## **Colco Consulting Pty Ltd**

# RE: Development Application DA2021/1059 – 56 Peronne Avenue Clontarf – Objection - Proposed Alterations and Additions to Existing Dwelling and Existing Secondary Dwelling.

Fig. 3.0-1 Above - Southern elevation – New roofed Entrance landing and door on lower ground level, and an open sided walkway bridge off the rear of the first floor.

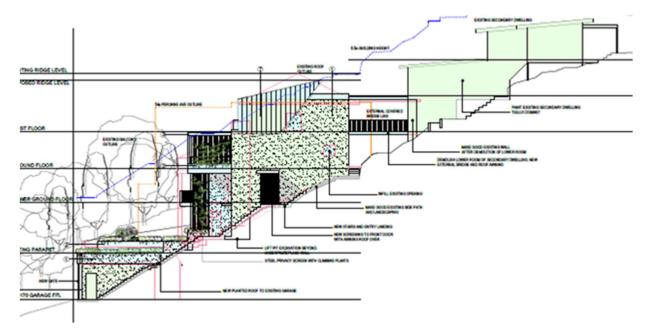
1. Our clients are most concerned that the existing amenity they enjoy will be interrupted by the proposal with regard to privacy overlooking and noise emanating <u>from the new entrance</u> <u>landing</u>, front door, the proposed Lift landing Although the drawings include screens, it is

considered that the screens will be inadequate and will not protect overlooking of their windows and property.

- 2. They also consider that additional acoustic noise will be generated by the location of the new entrance landing and also the proposed Lift.
- 3. <u>Our clients also object to the proposed new open sided bridge</u> linking the secondary dwelling to the principal dwelling being open sided where people using the bridge will be able to look directly into windows of their home and property.

<u>2.2. They would like to see the main entrance to the principal dwelling retained</u> or in a similar location to that existing and the proposed Lift also. Further that the bridge link include a full length privacy screen along the southern elevation so that it does not overlook their home.

- 3. That Council require an effective privacy screen be erected along the southern side of the walkway <u>that ensures maximum privacy to the occupants on No. 54 Peronne Avenue.</u>

Fig. 3.0-2 Above - Detail of southern side terrace screens and entry landing screens. Lift entrance shown with Blue arrow, Side entrance shown with a Yellow arrow.

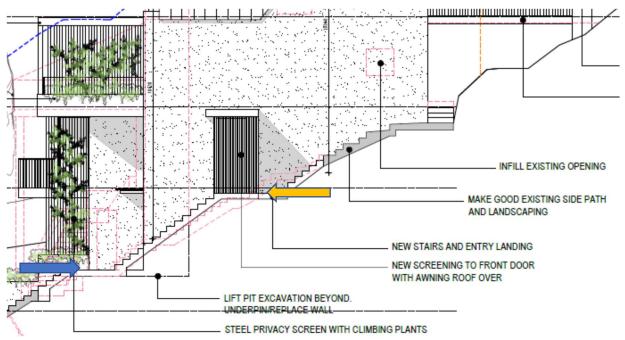
- 1. That Council require for all privacy screens, the submission of design detail including the width of open spaces in the proposed steel screens, and the width and angle of any vertical blades.

- 2. That Council require all privacy screens on the southern elevation, including terraces and at the front entrance landing and to the Lift landing are of a design <u>that ensures maximum</u> <u>privacy to the occupants on No. 54 Peronne Avenue.</u>
